HumeLink

Amendment Report

FIGURE 3-3a: Changes to worker accommodation facilities

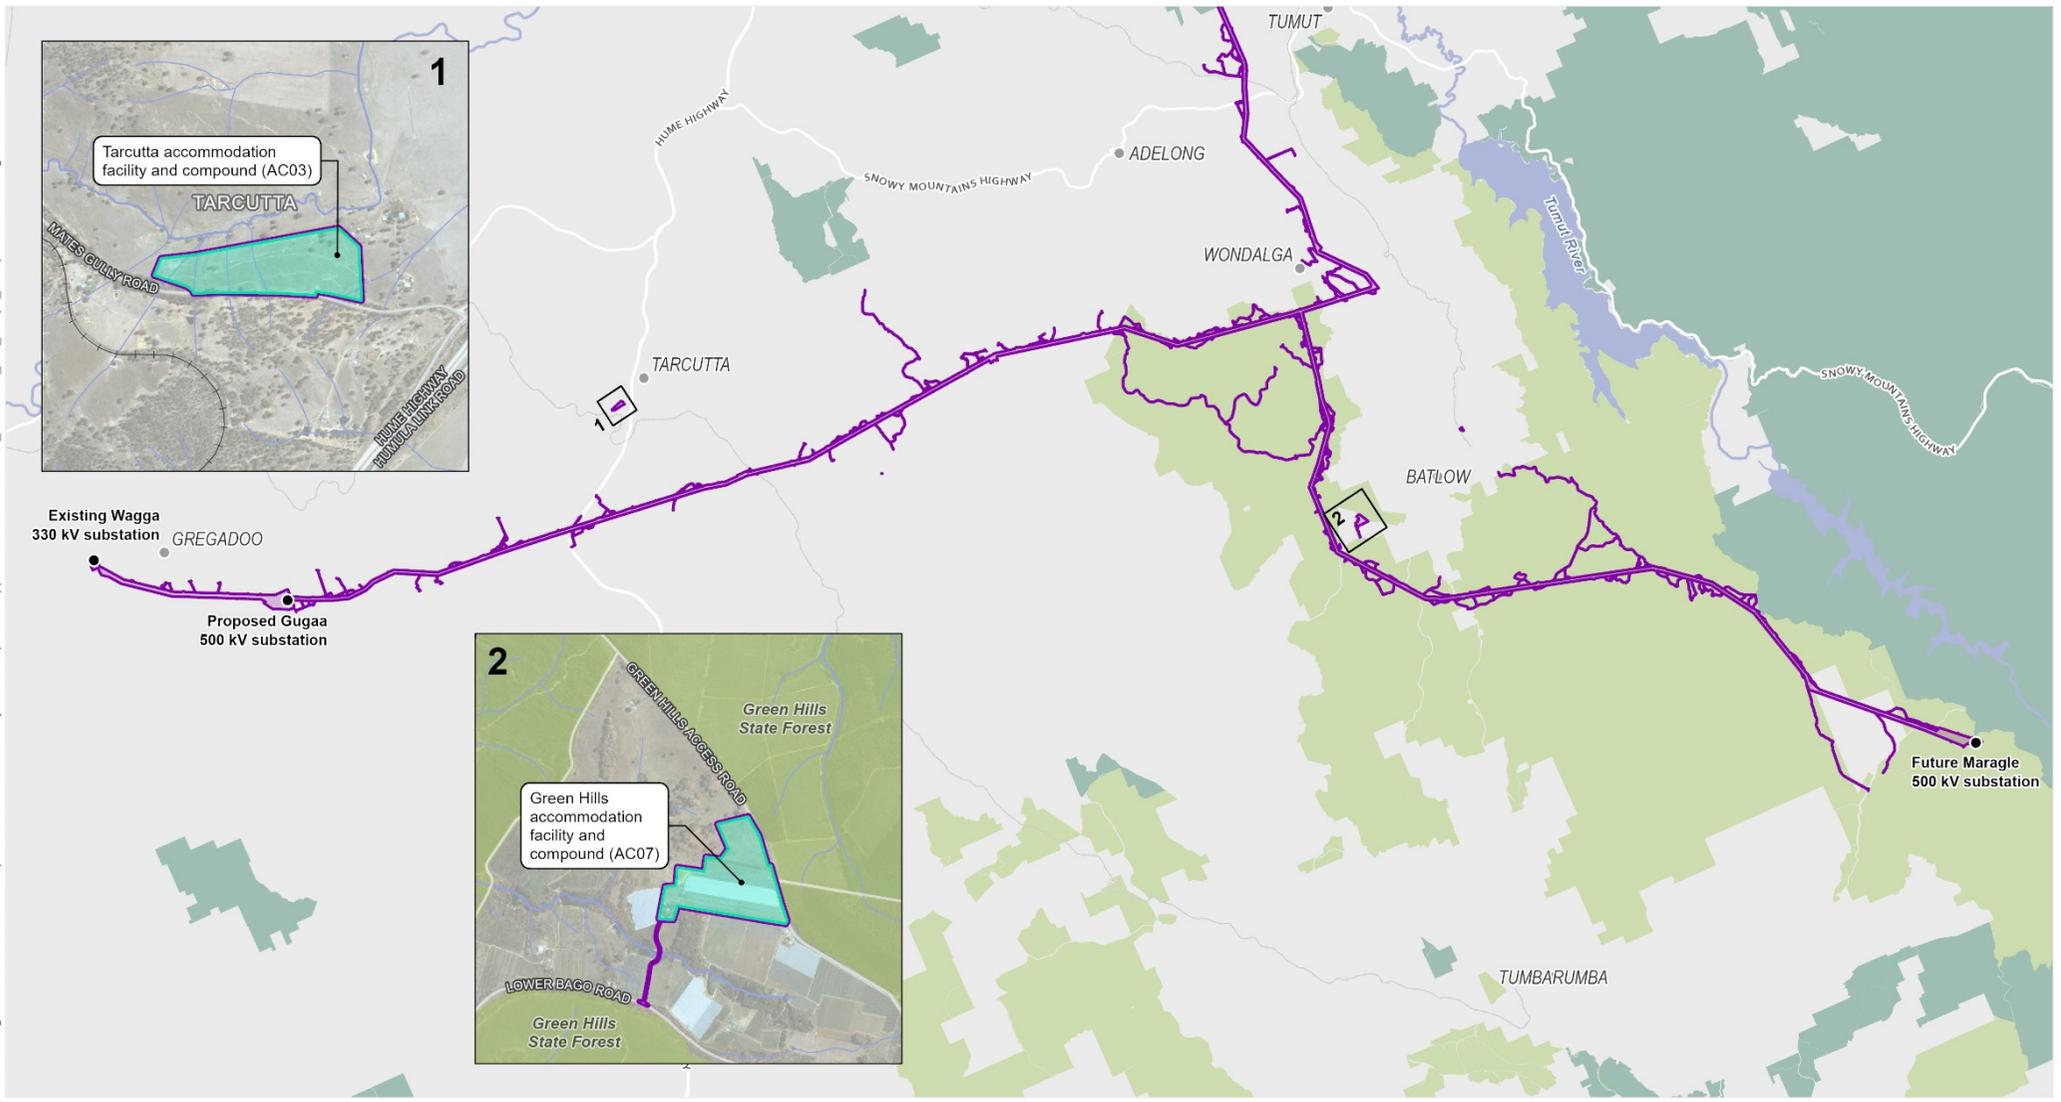
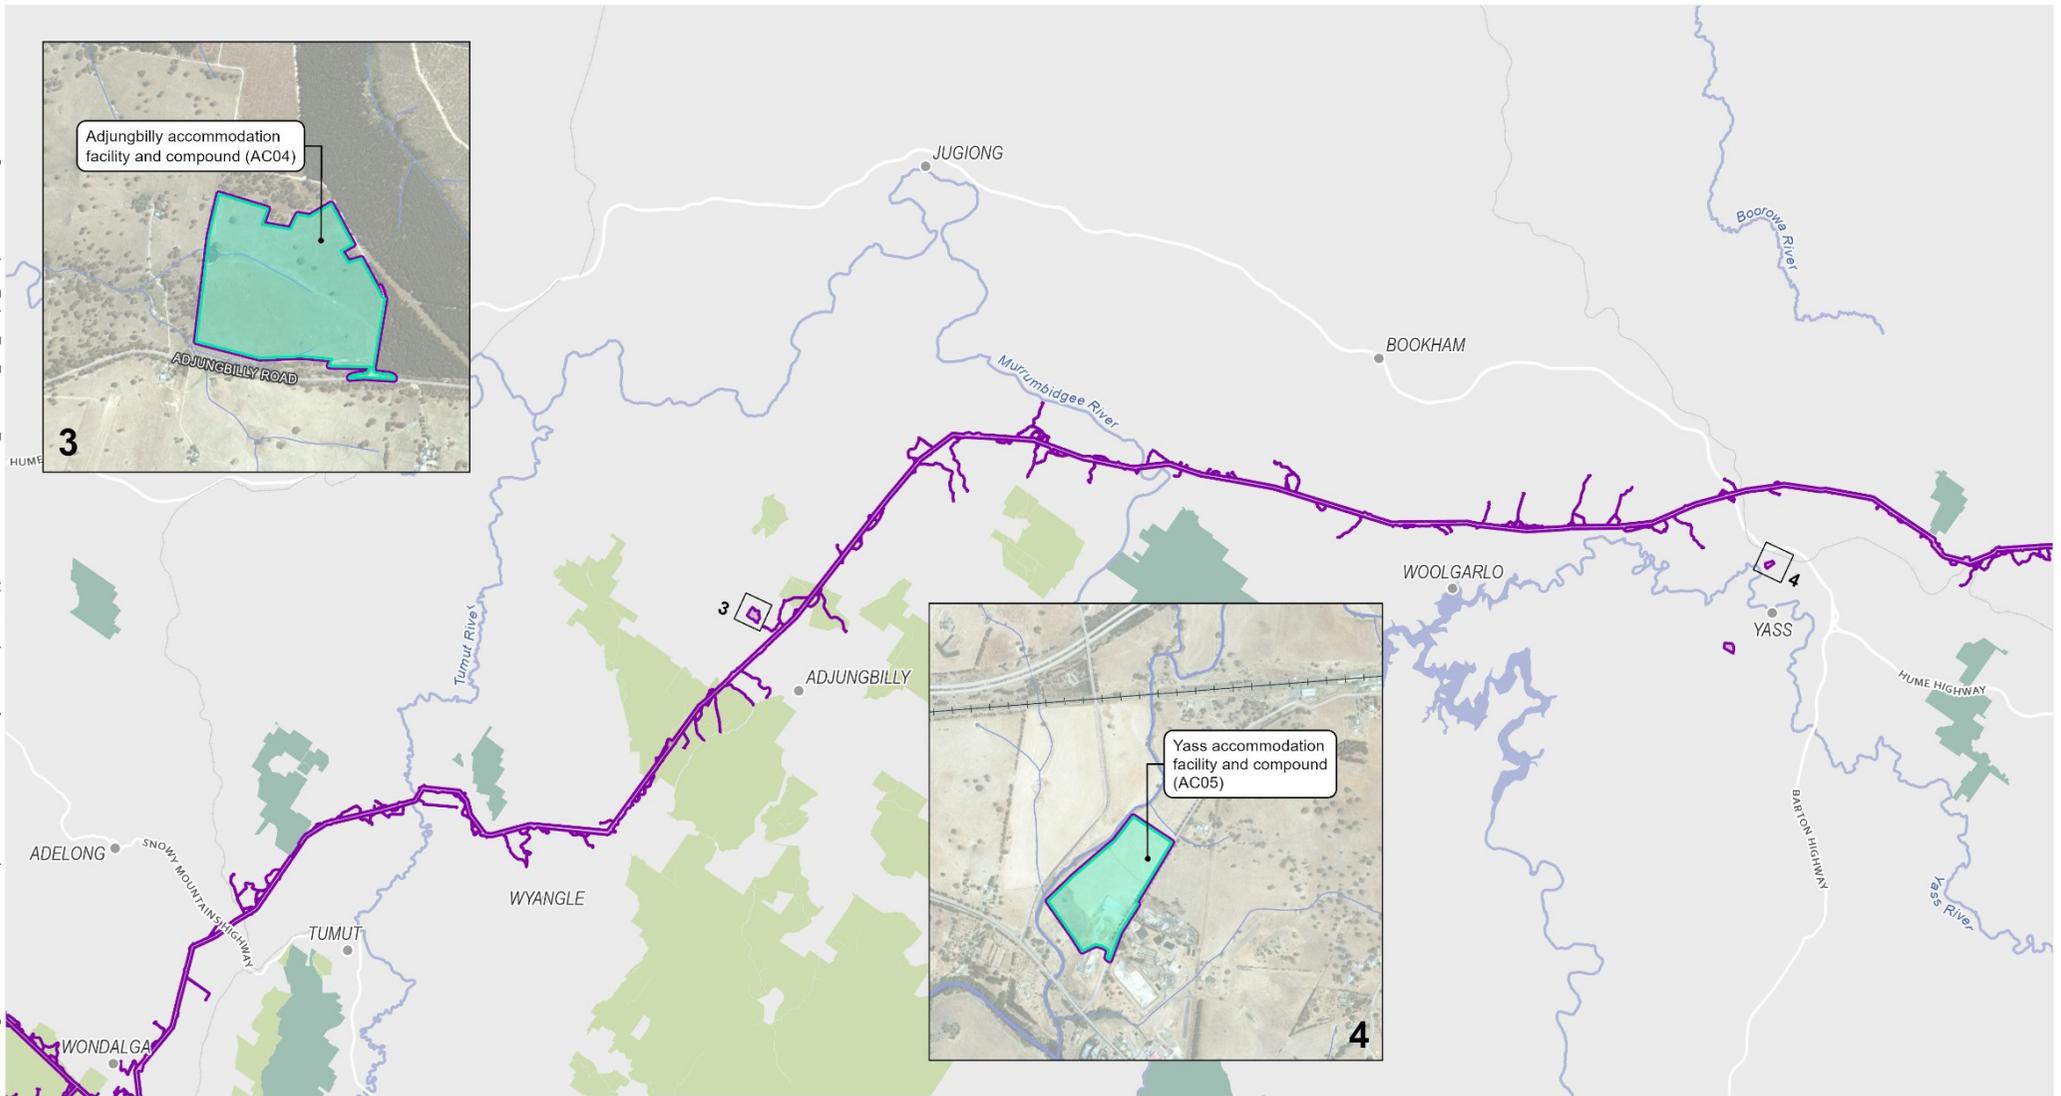
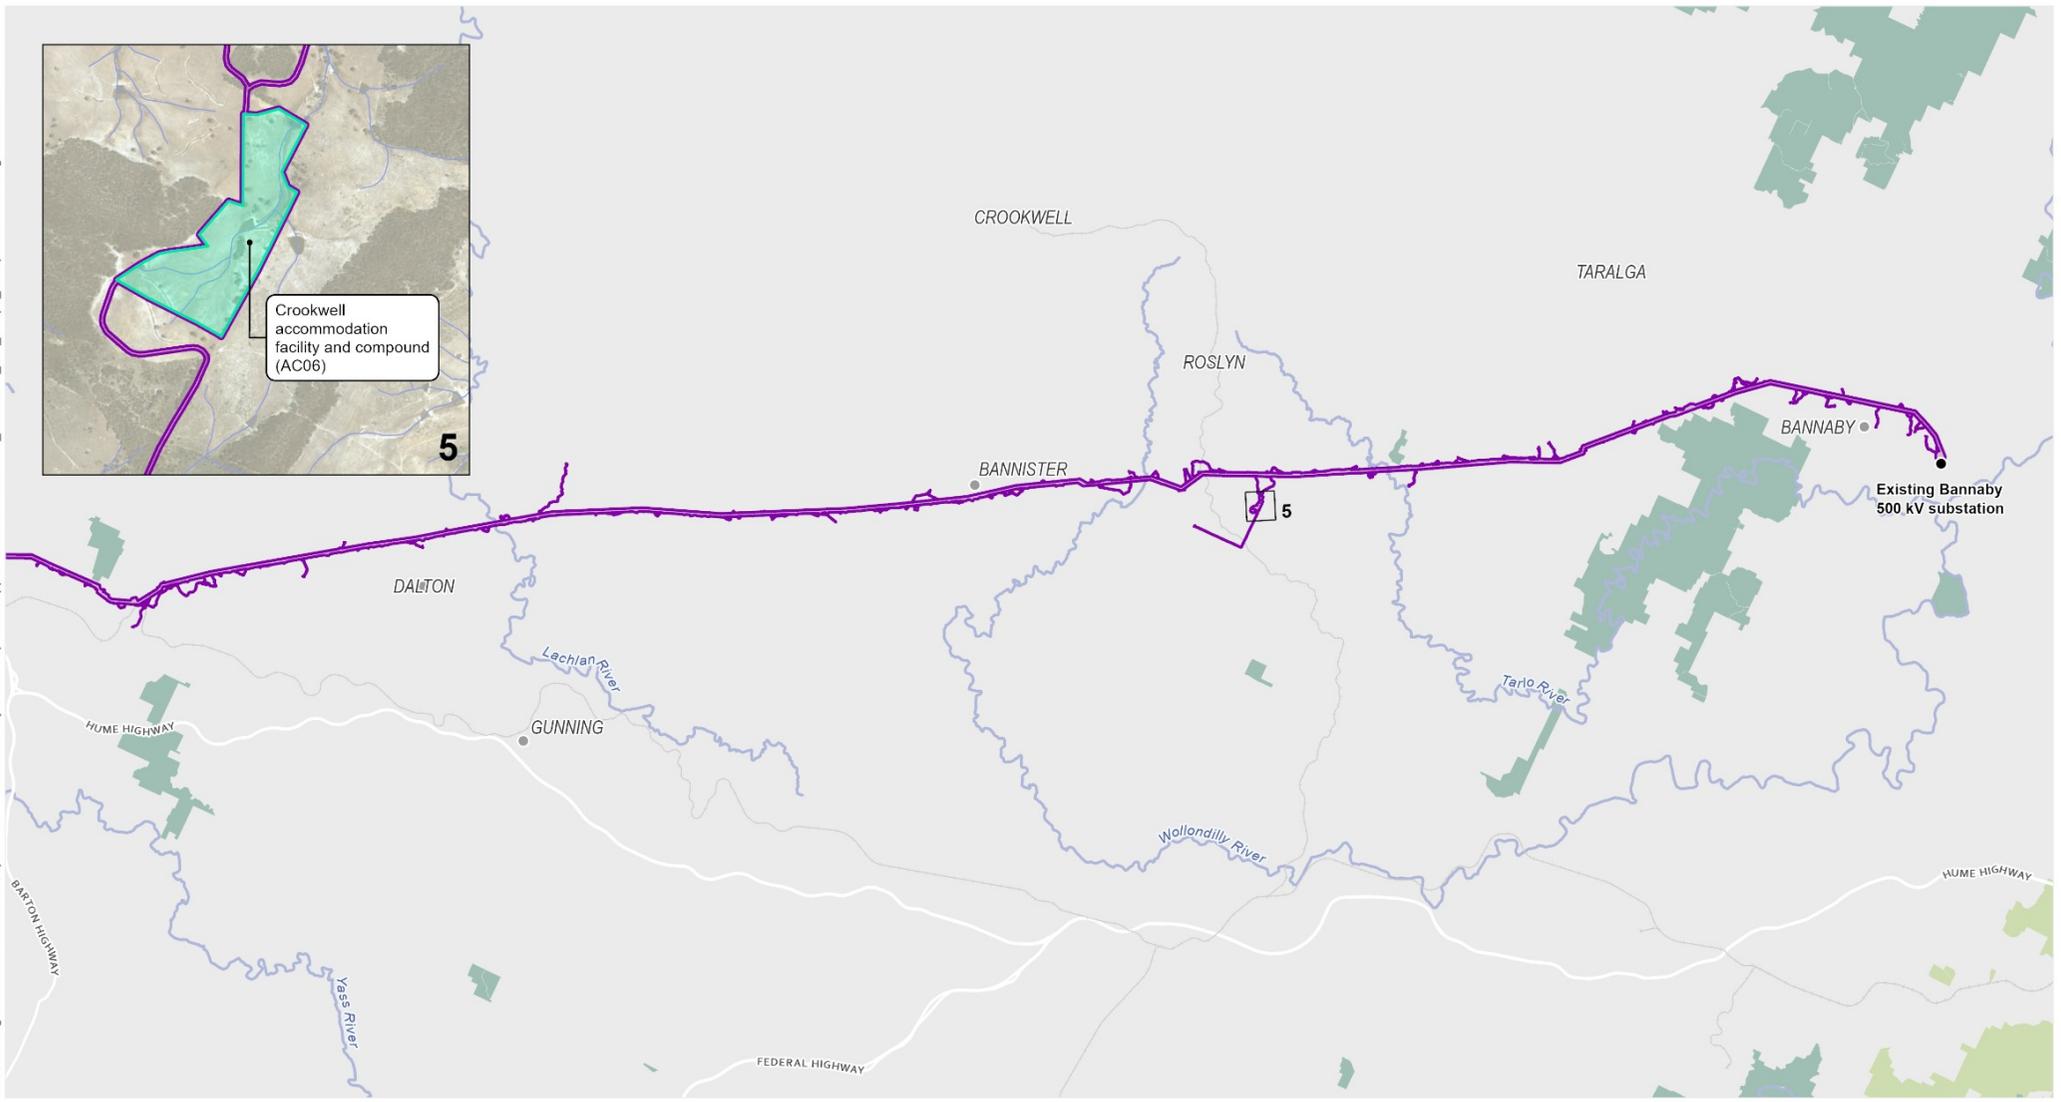
The new temporary worker accommodation facilities and construction compounds are described in Table 3-3 and shown in Figure 3-3. Further detail is provided in Appendix A (Updated project description).
